**RALEIGH COUNTY AIRPORT AUTHORITY
RALEIGH COUNTY, WEST VIRGINIA**

TAXIWAY F

ADDENDUM #2

THRASHER PROJECT #080-10038

**PLAN VIEW UNDERGROUND
DETENTION SYSTEM**
NOT TO SCALE

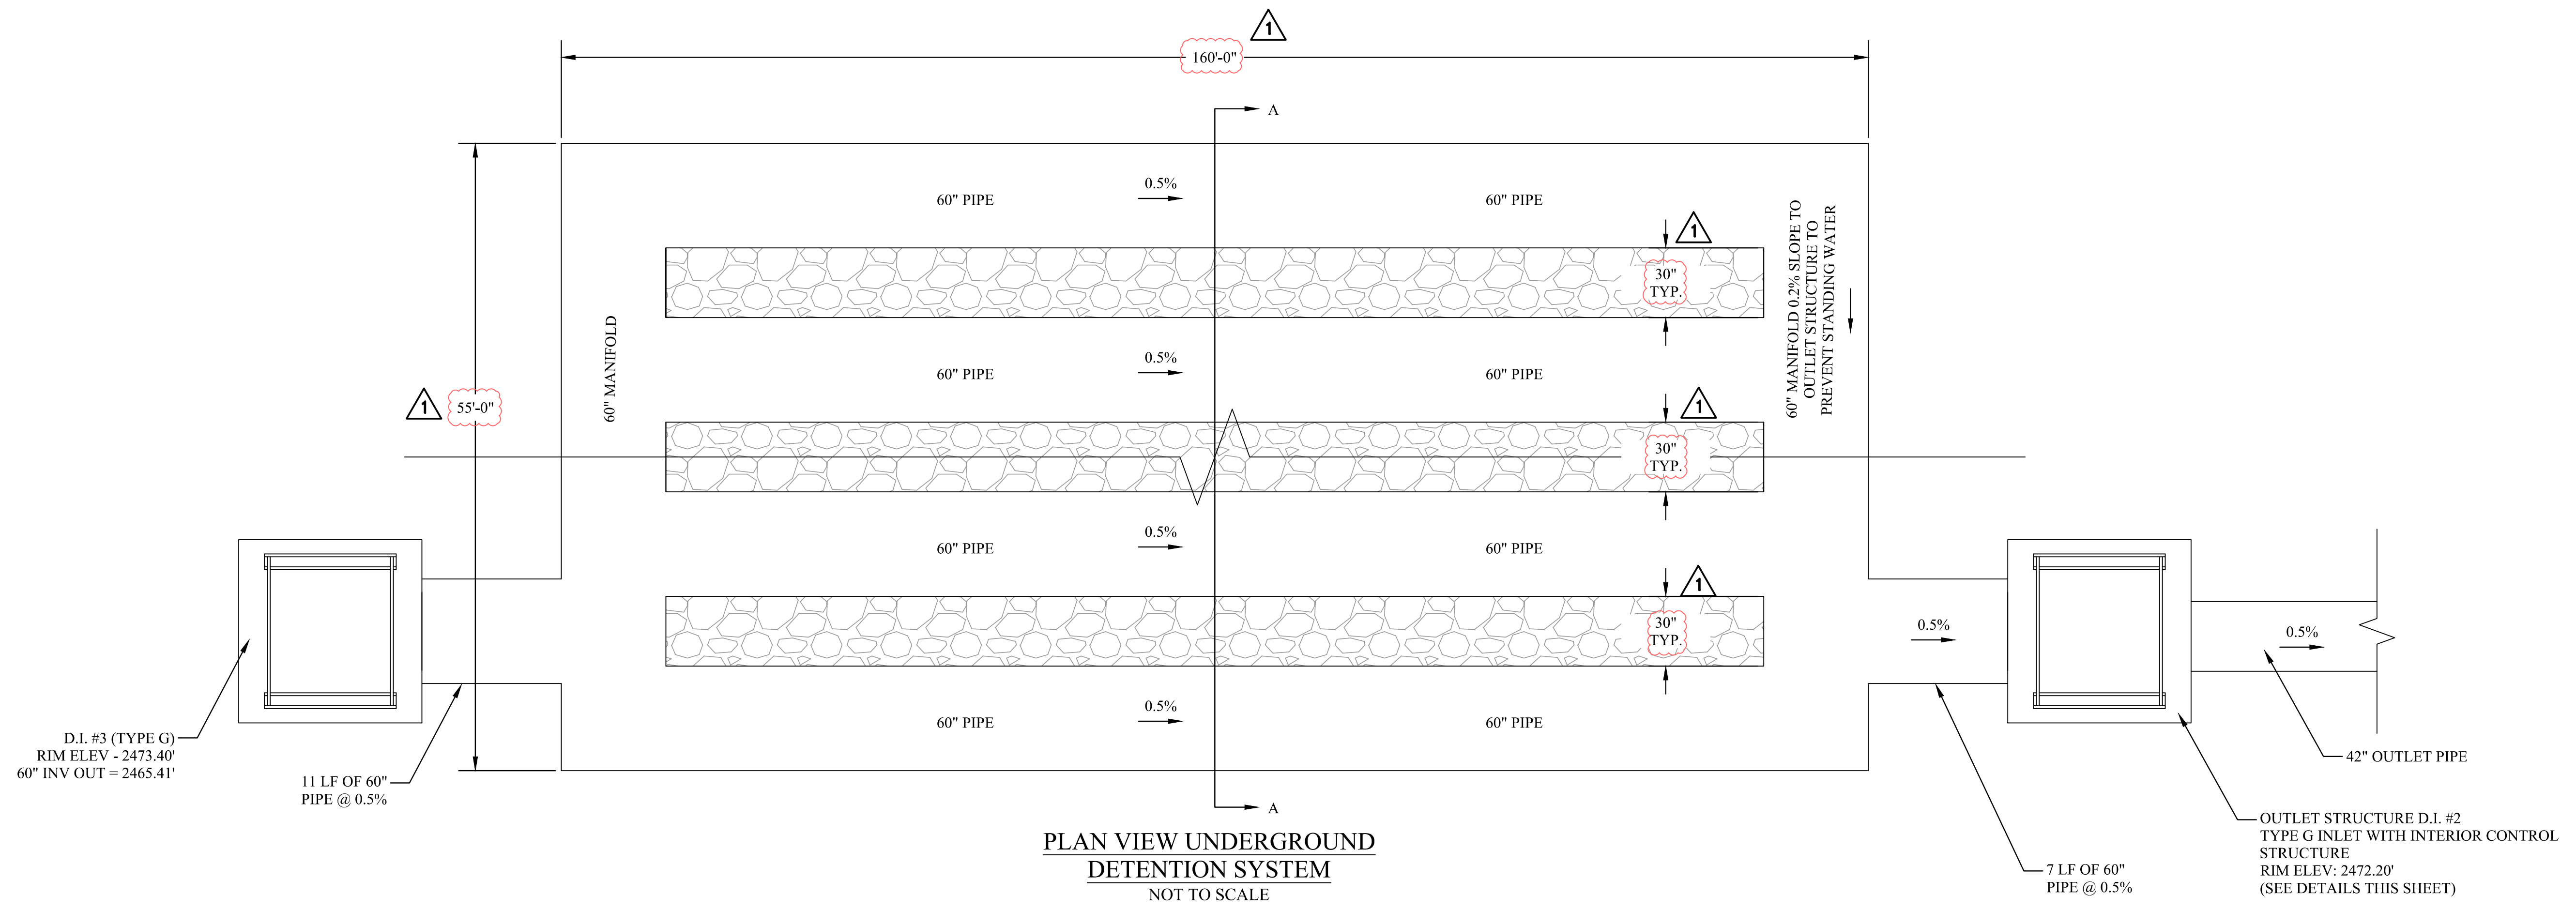
9. The Retention System manifolds have to be built with 30" between each 60" pipe for strength. The detail shows 1' separation in each of the 60" runs of pipe. Can this be altered to 30"?

Yes. Detail has been revised to show 30" separation.

NO.	BY	DATE	DESCRIPTION
1	NMJ	7/29/2022	REVISED SPACING OF PIPES - ADDENDUM #2
